## City of Ryde Local Planning Panel Report

<b>DA Number</b>	LDA2022/0023
<b>Site Address &amp; Ward</b>	130 Pittwater Road & 57 Thompson Street, Gladesville Lot 6 in Deposited Plan 598121 Lot 9 in Deposited Plan 10402
<b>Zoning</b>	B1 Neighbourhood Centre and R2 Low Density Residential
<b>Proposal</b>	Demolition of existing structures and construction of part 2, part 3 storey mixed use development comprising parking within basement 2, retail premises and loading docks within basement 1, a cafe, a medical centre and a liquor store on ground floor, parking at level 1 and a child care facility within level 2 and lot consolidation.
<b>Lodgement Date</b>	24 January 2022
<b>Property Owner</b>	Gladesville WW Pty Ltd
<b>Applicant</b>	The Trustee For Gladesville WW Investment Trust
<b>Report Author</b>	Sonya Constantinou – Consultant Town Planner (CPS)
<b>No. of Submission</b>	Fourteen (14) submissions received
<b>Cost of Works</b>	\$ 8,625,000.00
<b>Reason for LPP Referral</b>	<p><b>Contentious development</b> – (b) in any other case – is the subject of 10 or more unique submissions by way of objection - <i>Schedule 1, Part 2 of Local Planning Panels Direction</i>; and</p> <p><b>Departur

**Figure 20:** Location of the contravention of the building height standard and the maximum building heights shown in red.  
Source: Floor Plan Level 2, TesserArch dated 23 January 2023.

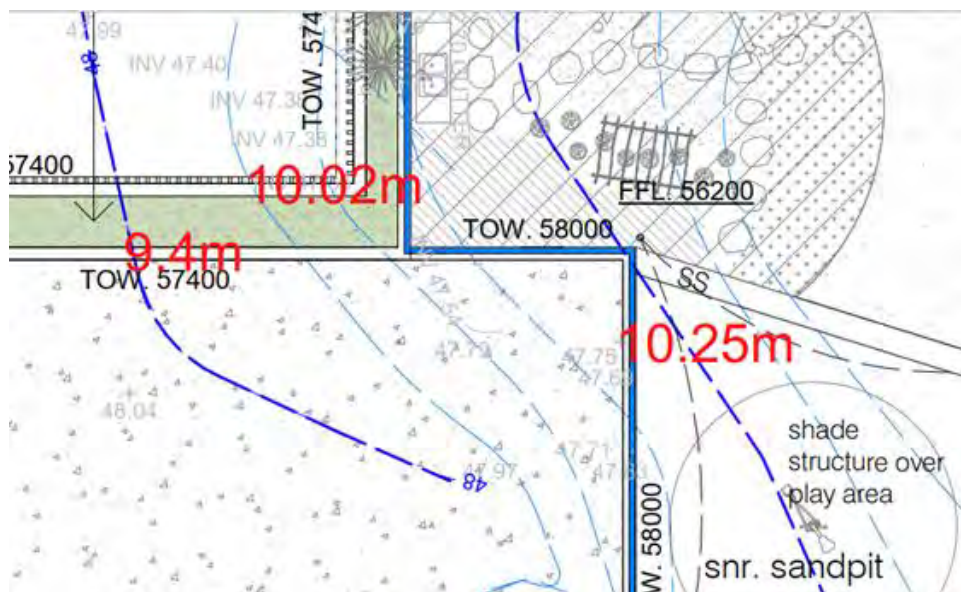
When applied to the subject site, the existing ground level would be RL 47.38 and RL 47.75 respectively at the locations highlighted within the photograph provided at **Figure 19**. The top of the acoustic screens and walls above these points are RL 57.4 and RL 58 respectively. This results in a vertical distance of 10.02m and 10.25m respectively, therefore contravening the building height standard (refer **Figure 20**).

The applicant’s written request subtracts the concrete slab thickness from the surveyed spot level to establish the existing ground level. This interpretation is incorrect, as the building height measurement is to be taken from the ground level that is ‘existing’ (per the definition provided above), not a presumed pre-existing ground level that may have been modified in the past. As such, the applicant’s written request highlights a greater variation to the standard than the assessment undertaken by Council.

Assessment Officer's Comments: The building height contravention is confined to the acoustic fence provided for the outdoor play area and the boundary wall of the building demonstrated within **Figure 20**.

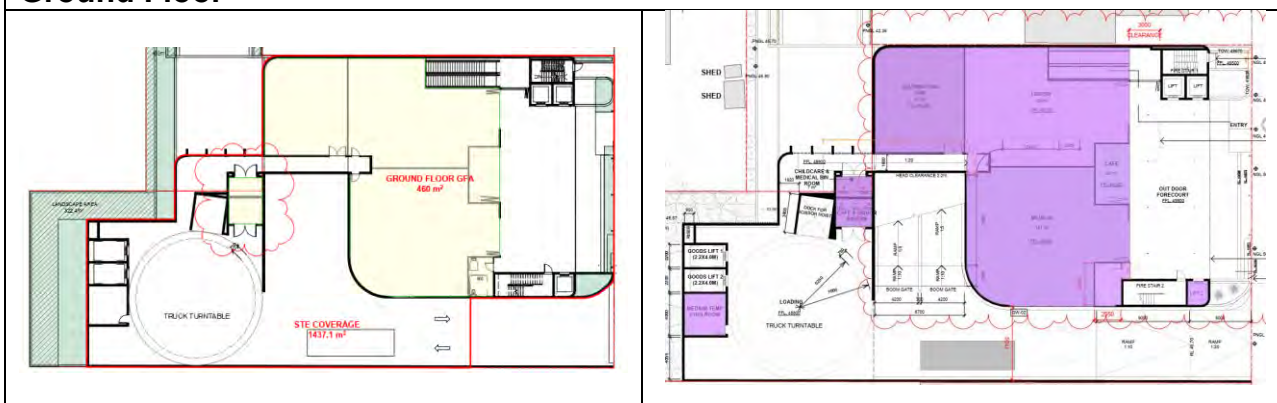
The written request prepared by Think Planners has identified the contravention to the standard as an FSR of 1.41:1 for land within the B1 zone and an FSR of 0.023:1 for land within the R2 zone.

The assessment has found that the FSR of the development is 1.48:1 within the B1 zone and 0.023:1 within the R2 zone. A breakdown of the GFA per level has been provided within the table below. Diagrams detailing the difference between applicant and Council GFA calculation is included below also.

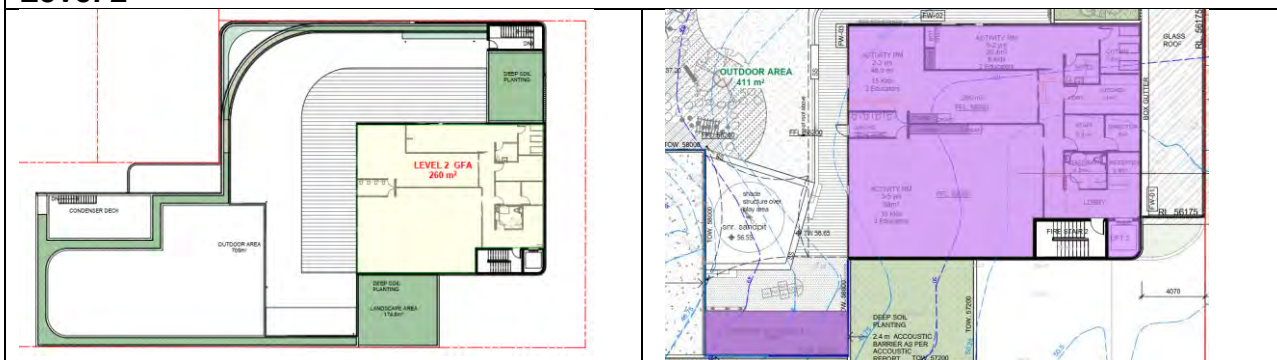
At the ground floor the Council GFA calculation has included the traveller for the shop, child care centre lift and cool room.

At Level 2 the Council GFA calculation has included the child care centre lift and outdoor storage rooms for the child care centre.

**Figure 21:** 3D massing diagram contained in the clause 4.6 written request for FSR contravention.

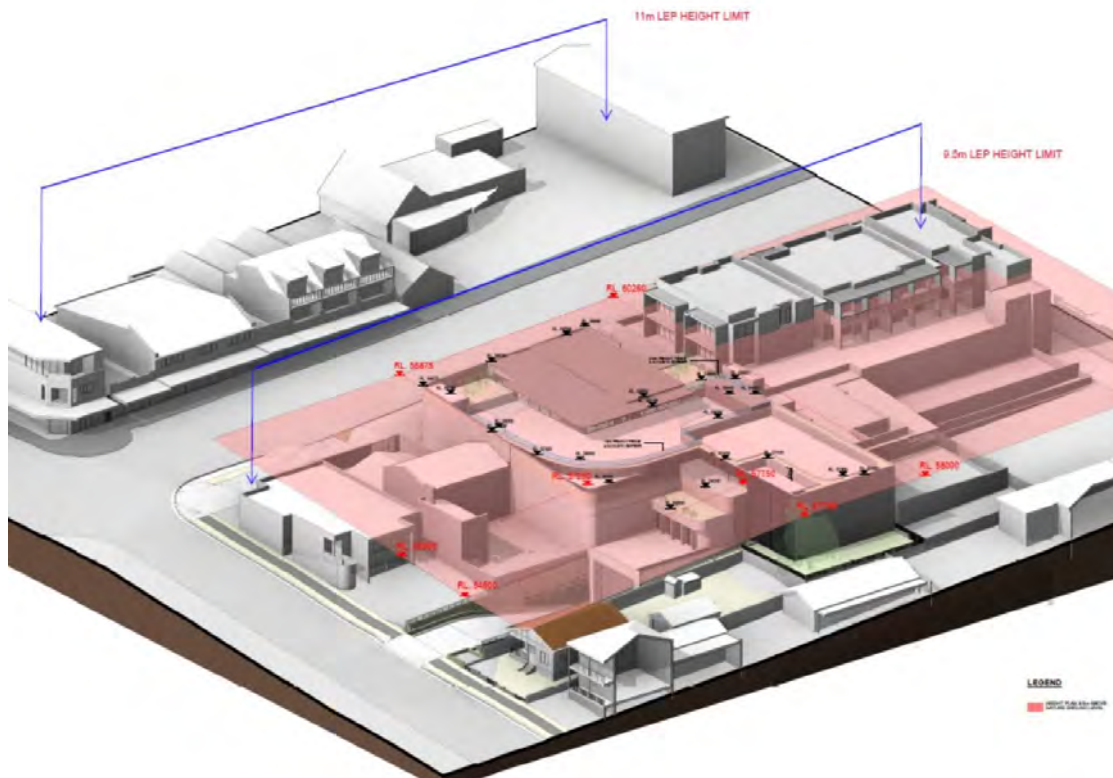
It is agreed with the applicant that a better representation of the building's bulk can be observed from the 3D massing extract contained on page 9 of the written request (**see Figure 21 below**).

That being said, the development proposed on 57 Thompson Street is limited to a basement driveway ramp, and minimal above ground structures. In this respect, it is agreed with the applicant that the lack of development of the R2 portion helps transition the perceived bulk and scale, and assists in minimising amenity impacts to the adjoining residential properties. Objective 4.4(a) is satisfied as the applicant has demonstrated the development will be compatible with the bulk of future development in the local area.
